Malibu Creek Ecosystem Restoration Study
Los Angeles and Ventura Counties, California

Appendix U

**Resource Agency Coordination Documents
(ESA and 401)**

**U.S. Army Corps of Engineers
Los Angeles District**

Figure 3 Restored Aquatic Habitat Connectivity - Upstream Barriers

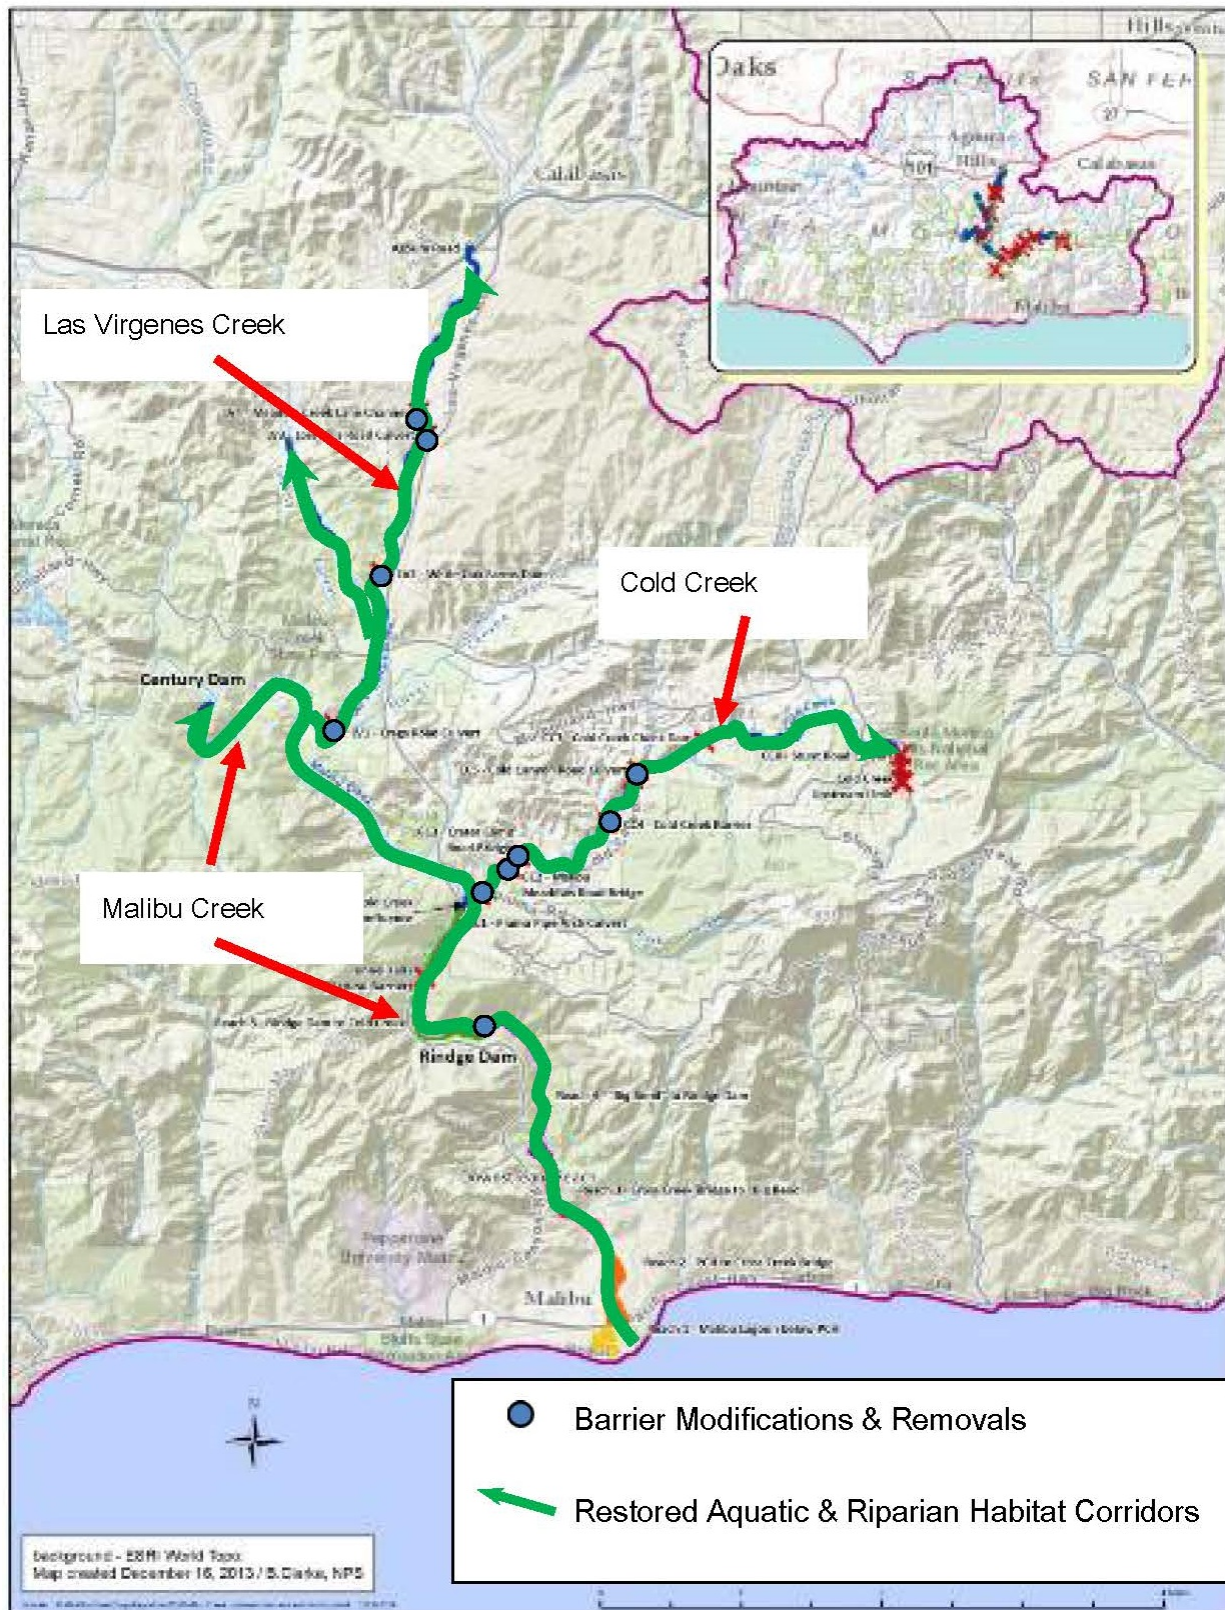
Action Area.—This section of the BA should be updated to better define the location and extent of specific components of the proposed action. Although Figure 3 (BA at pg. 7) is referenced as the “Action Area” individual components of the proposed action and associated project footprints are not clearly identified. For each component of the proposed action, describe the instream linear extent (upstream and downstream) of the work area. Additionally, the action area description should account for the upstream and downstream extent of any potential effects, which can transcend the physical location of a construction activity.

- Clarify whether eight upstream barriers (pg. 9) or nine (Figure 3) will be removed or modified.
- Clarify the following statement “Habitat Evaluation outputs remain the same as those calculated for the NER Plan, but overall costs increase (pg. 10).”

There are eight upstream barriers to be removed. Figure 3 in the BA, shows nine, one has been removed by another group and is no longer part of the project.

Figure 2. Rindge Dam Schematic Sediment Removal Plan

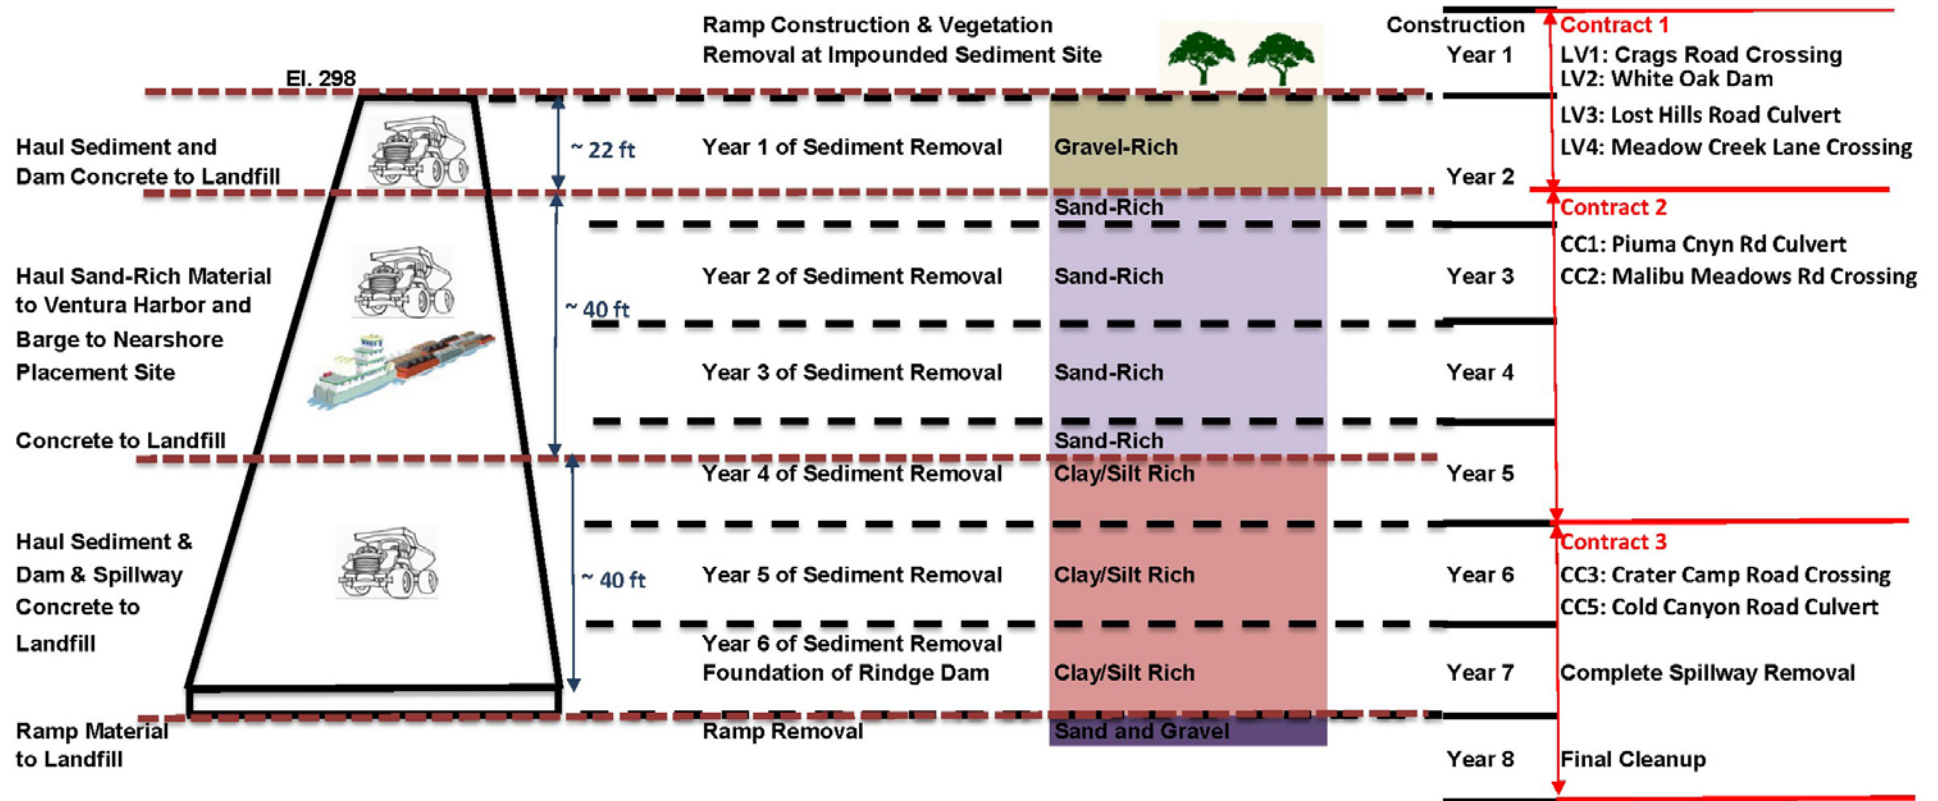
4. A design drawing depicting the sections of dam and spillway to be removed incrementally over the 8 years of construction. The schematic provided by the Corps does not clearly identify the dam crest or spillway elevations following each season of construction (Corps 2018, Fig. 2). Provide design plans or drawing that clearly depicts existing dam crest and spillway elevations, and subsequent dam crest and spillway elevations following removal of sediment each season.

A design depicting the sections of dam to be removed incrementally is shown on Figure 2. The spillway would be removed sometime during year 4.
